CO 119 Bikeway Application- Supplemental Materials

SH 119 BICYCLE AND PEDESTRIAN CONNECTIVITY STUDY

CONCEPT SUBMITTAL

Appendix A
Concept Plan Mark-Up

PLAN AND PROFILE

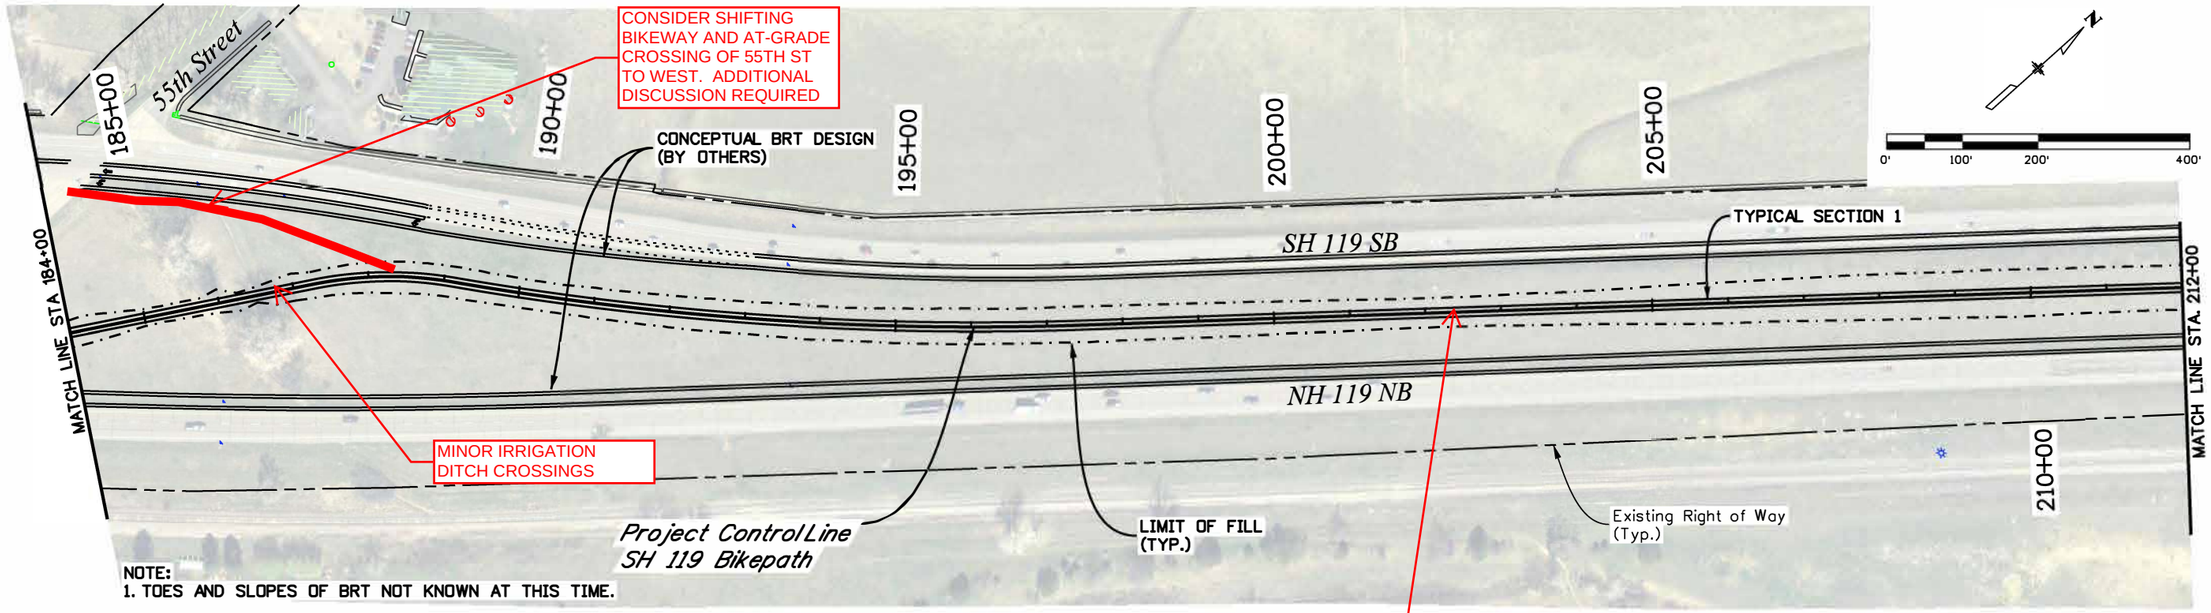
ALIGNMENT GOOD AS-IS. TERRAIN IS FLAT AND WIDE OPEN WITH NO TREES OR WETLANDS

As Constructed	PLAN AND PROFILE			Project No./Code
No Revisions:				STA 1191-035
Revised:	Designer: KRC	Structure Numbers		22455
Void:	Detailer: REW			Sheet Number
	Sheet Subset: P&P	Subset Sheets: 5 of 18

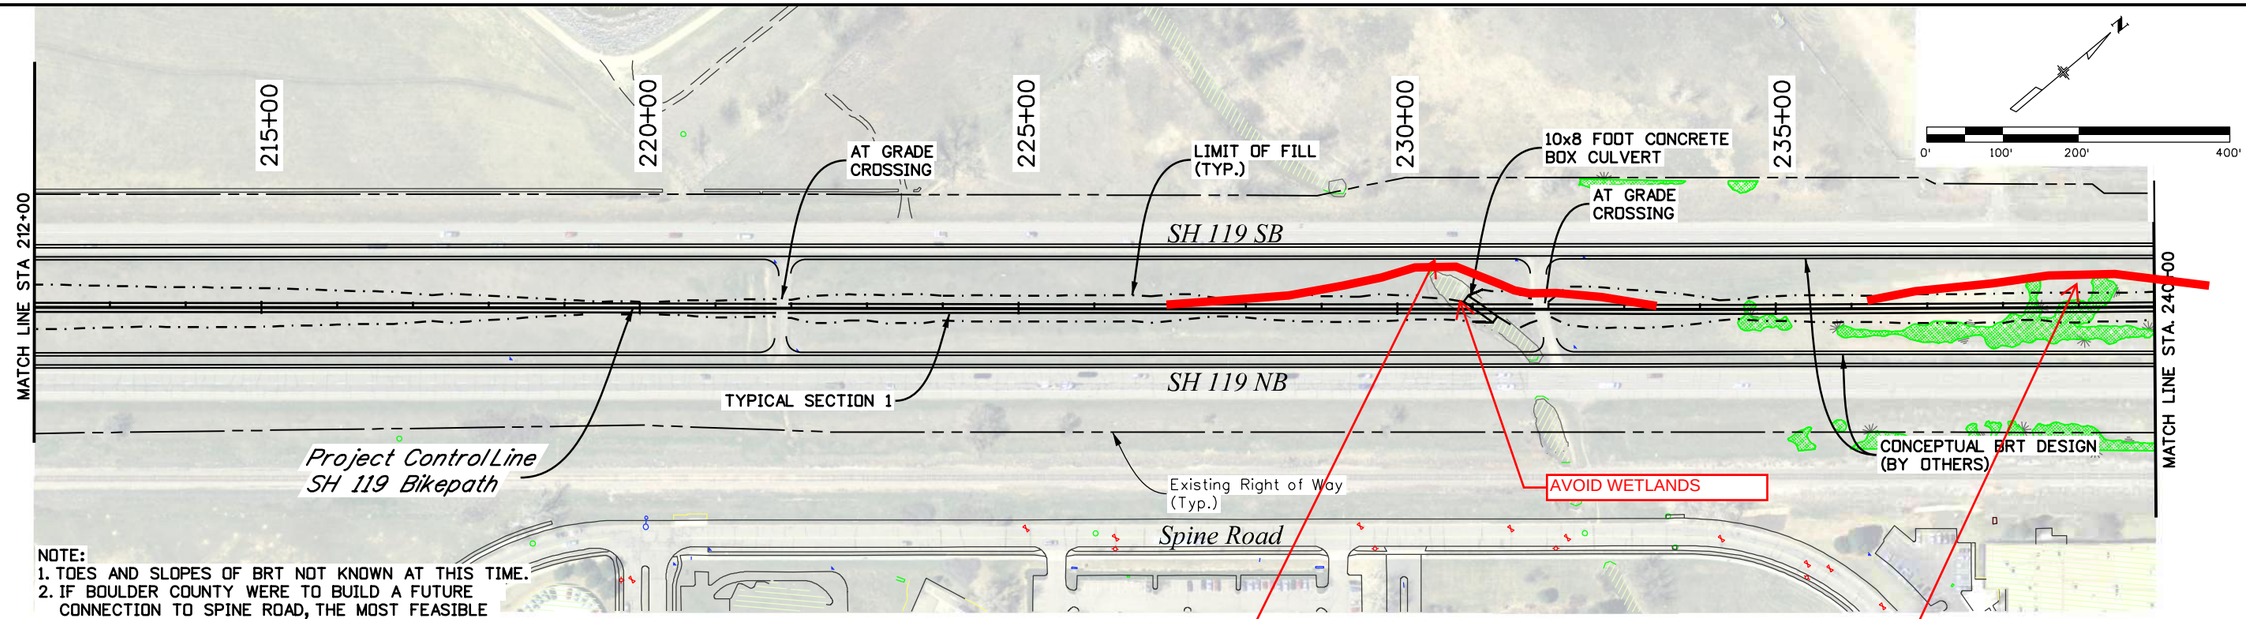
SHIFT BIKEWAY WEST TO AVOID WETLANDS. EXTEND EXISTING BOX CULVERT

V.C. = 80.00'
K
SHIFT TO AVOID WETLANDS

CONSIDER SHIFTING WEST TO AVOID WETLANDS. REVIEW TOPO. WETLANDS WERE NOT NOTICED IN SITE WALK

CAN WE MOVE UNDERAPSS HERE FOR DRAINGE

PLAN AND PROFILE

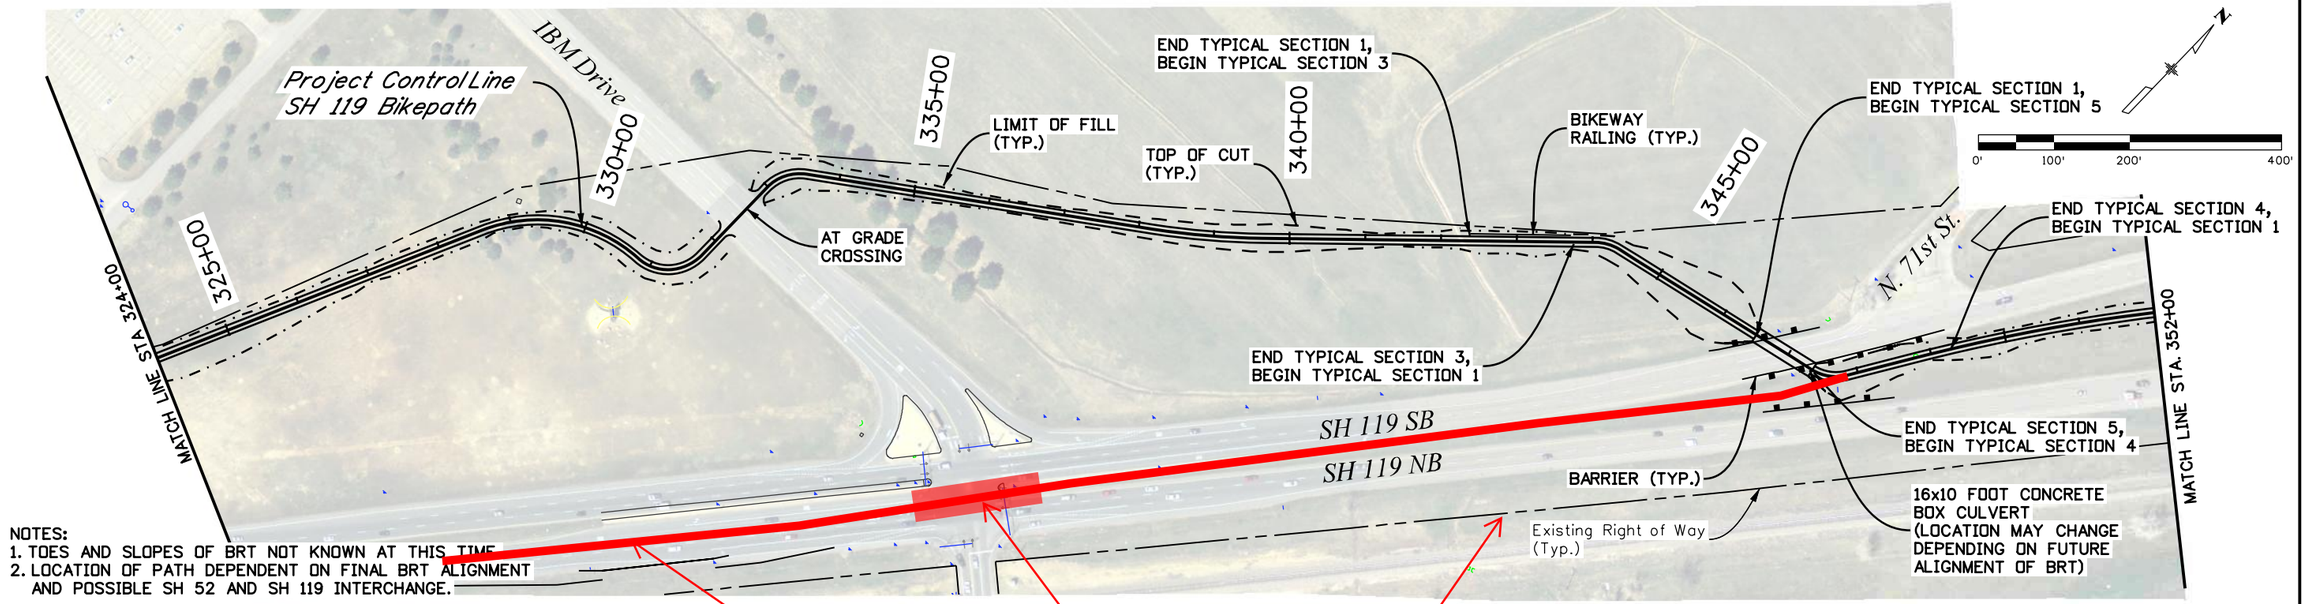
COORDINATE BIKEWAY AND UNDERPASS WITH MP. SHIFT UNDERPASS WEST OF STATION IF POSSIBLE TO IMPROVE DRAINAGE

NEED TO DETERMINE TAILWATER ELEVATOIN

AVOID WETLANDS

SHIFT BIKEWAY ALIGNMENT WEST AND EXTEND BOX CULVERT

PLAN AND PROFILE

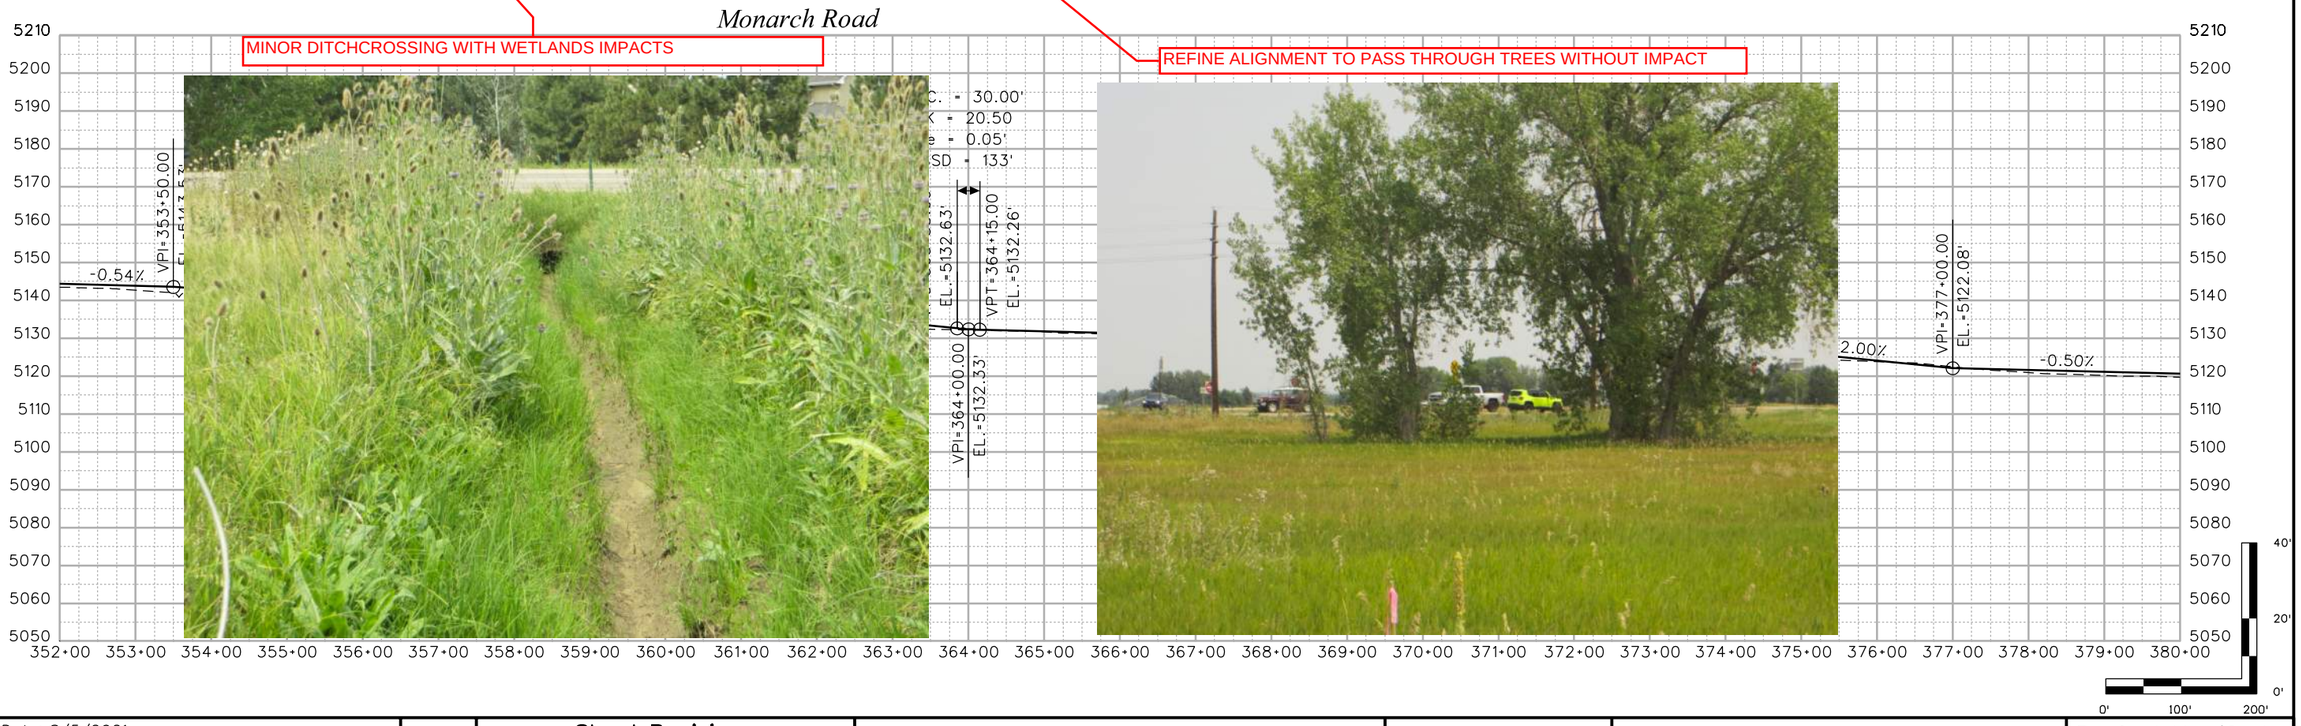
INCREASE SKEW OF UNDERPASS TO IMPROVE SIGHT LINES AT BOTH SIDES OF THE UNDERPASS. THIS WILL BE ESPECIALLY IMPORTANT AT THE NORTH APPROACH WITH THE CONFINING RETAINING WALLS. LAY BACK WALLS AS MUCH AS POSSIBLE

As Constructed	PLAN AND PROFILE			Project No./Code
No Revisions:				STA 1191-035
Revised:	Designer: KRC	Structure Numbers		22455
Void:	Detailer: REW			Sheet Number
	Sheet Subset: P&P	Subset Sheets:	11 of 18

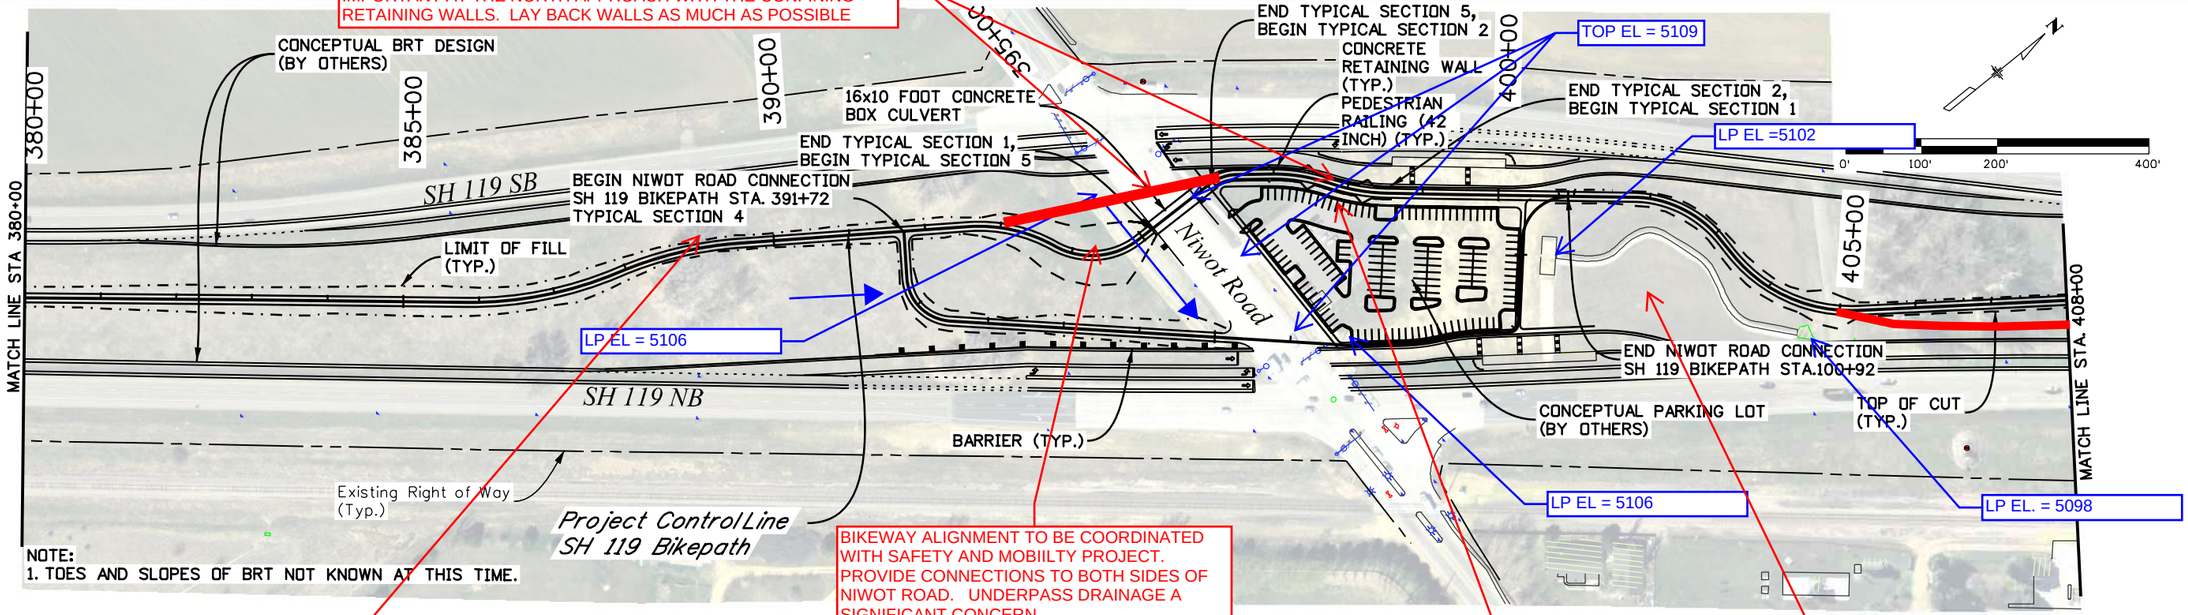
BIKEWAY ALIGNMENT TO BE COORDINATED WITH SAFETY AND MOBIILTY PROJECT. PROVIDE CONNECTIONS TO BOTH SIDES OF NIWOT ROAD. UNDERPASS DRAINAGE A SIGNIFICANT CONCERN

VERIFY THAT ALIGNMENT AVOIDS IMPACTS TO TALL COTTONWOODS

SOIL AND VEGETATION SHOWS SIGNS OF STANDING WATER WHERE THE UNDERPASS IS PROPOSED

REVIEW EXISTING DRAINAGE FACILITIES AND DRAINAGE REPORT
